**MICROCHIP****PIC18F6585/8585/6680/8680****PIC18F6585/8585/6680/8680 Data Sheet Errata****Clarifications/Corrections to the Data Sheet:**

In the Device Data Sheet (DS30491C), the following clarifications and corrections should be noted. Any silicon issues related to the PIC18F6585/8585/6680/8680 will be reported in a separate silicon errata. Please check the Microchip web site for any existing issues.

64-Pin TQFP

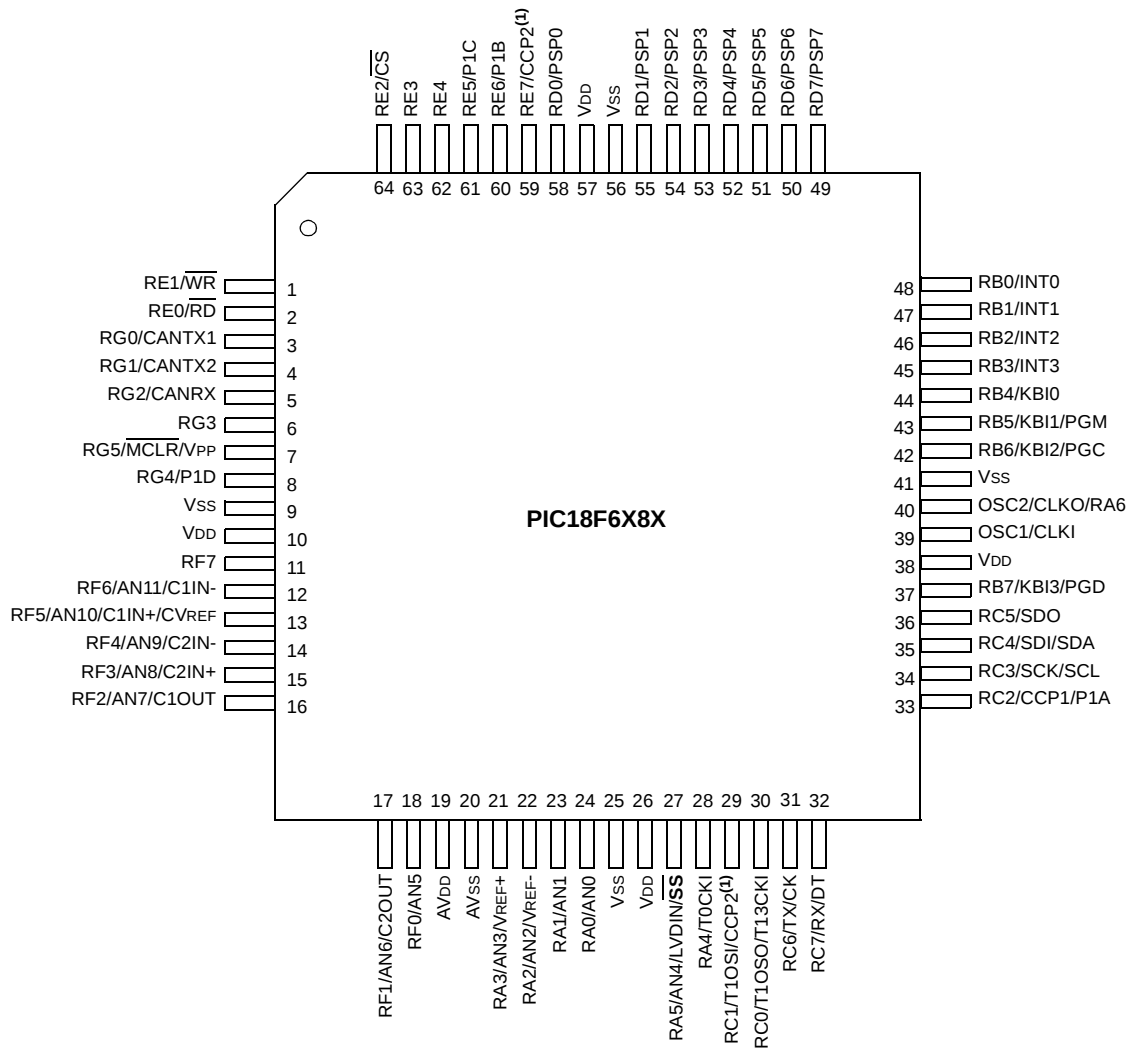
The pin number of the Serial Pin Select (SPI) mode's slave select signal ($\overline{SS}$) is changed to the following:

- PIC18F6X8X, TQFP package – Pin 27
- PIC18F6X8X, PLCC package – Pin 38
- PIC18F8X8X, TQFP package – Pin 33

The $\overline{SS}$ signal is on the same pin as the RA5/AN4/LVDIN signals, not on the pin with the RF7 signal.

This change is made in the following locations, each indicated by bold text:

- Pin Diagram, PIC18F6X8X, 64-Pin TQFP package – Page 3
- Pin Diagram, PIC18F6X8X, 68-Pin PLCC package – Page 4
- Pin Diagram, PIC18F8X8X, 80-Pin TQFP package – Page 5
- Block diagram, PIC18F6X8X – Page 6
- Block diagram, PIC18F8X8X – Page 7
- Table 1-2, PIC18F6585/8585/6680/8680 Pinout I/O Descriptions – Page 8
- Figure 10-2, Block Diagram of RA3:RA0 and RA5/ $\overline{SS}$ Pins – Page 9
- Figure 10-15, RF7 Pin Block Diagram – Page 9
- Table 10-11, PORTF Functions – Page 9
- **Section 17.3 “SPI Mode”** – Page 10
- Figure 17-1, MSSP Block Diagram (SPI Mode) – Page 10

FIGURE 10-15: RF7 PIN BLOCK DIAGRAM

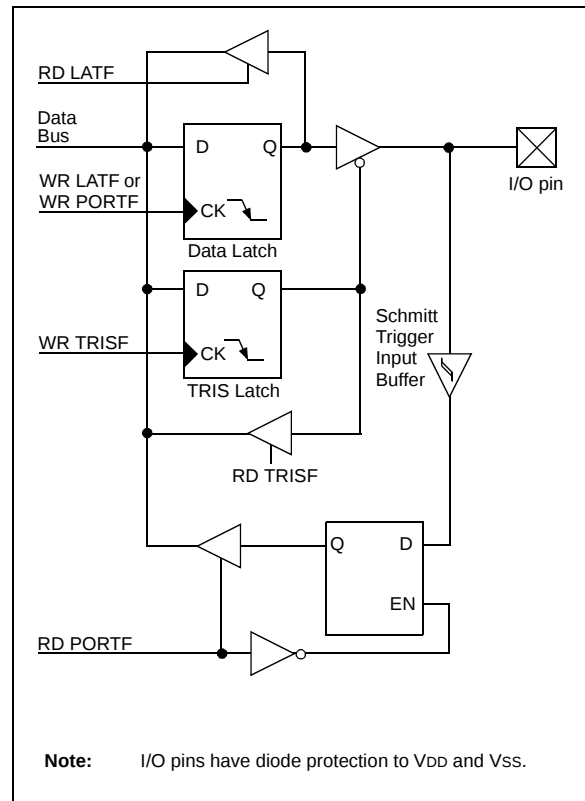
Note: The $\overline{SS}$ signal was removed from this diagram.

FIGURE 17-1: MSSP BLOCK DIAGRAM (SPI MODE)

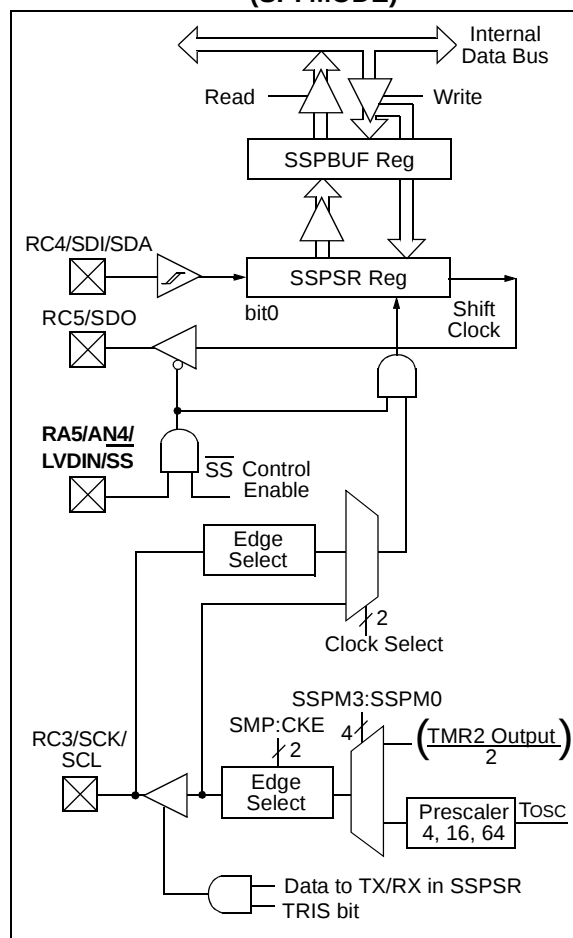
- Slave Select ($\overline{SS}$) – **RA5/AN4/LVDIN/ $\overline{SS}$**
